Sent: 5/05/2021 4:08:48 PM
Subject: DA/2021/0383 - 53B Amourin Street, North Manly - Objection Letter Submission
Attachments: Objection Letter - 53B Amourin Street, North Manly.pdf;

**Submission in regards to DA/2021/0383 Development Application
53B Amourin Street, North Manly**

“Alterations and additions to a dwelling house including garage.”

Figure 4– 3pm shadow diagram with additional shadow in **mustard** (Bewoner Studio 2021)

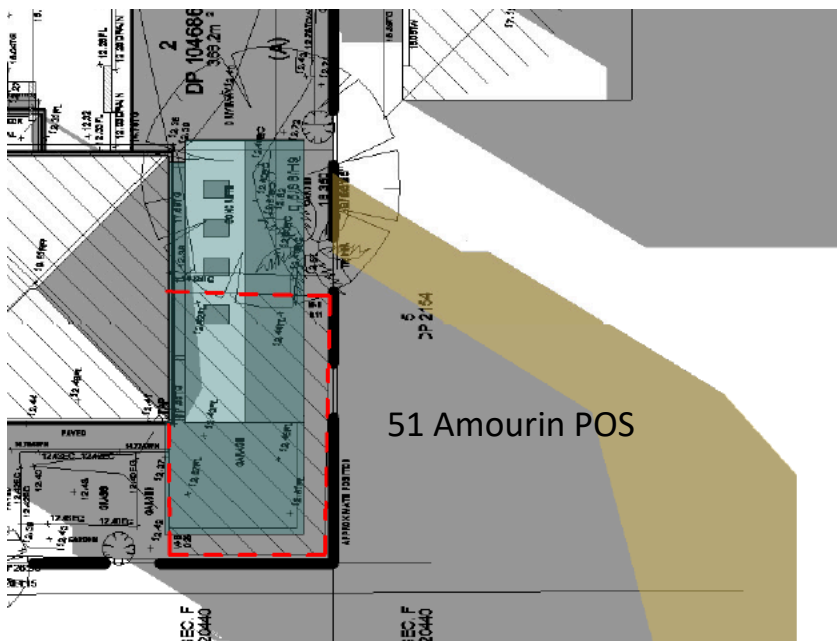
The works proposed under the subject DA will substantially decrease the amount of sunlight received by this space, particularly during the afternoon as per figure 4 where a large amount of the garden and decking is already shadowed.

The above example is identical to the circumstances imposed by the DA on the rear garden of 51 Amourin Street. As highlighted within figure 4, the proposal will block a significant amount of sunlight during the afternoon. This will have a detrimental impact on the current and future residents, and cannot be supported given that it is a direct result of a side setback non-compliance.

- a) **Action:** Remove the upper floor above the garage, or implement a 2m upper floor side setback and 6m rear setback for any addition above the garage.
Outcome: This will achieve compliance with WDCP 2011 built form objectives, and reduce overshadowing and any visual bulk impact for 51 Amourin Street.
- b) **Action:** Extend the upper floor to the west above the existing ground floor deck space.
Outcome: This results in a larger upper floor without negative amenity impacts for No. 51.
- c) **Action:** Provide landscape screening of any built form within the eastern side setback, ensuring that it is as high as the highest point of any addition.
Outcome: This will soften the visual appearance of any additions from 51 Amourin Street.
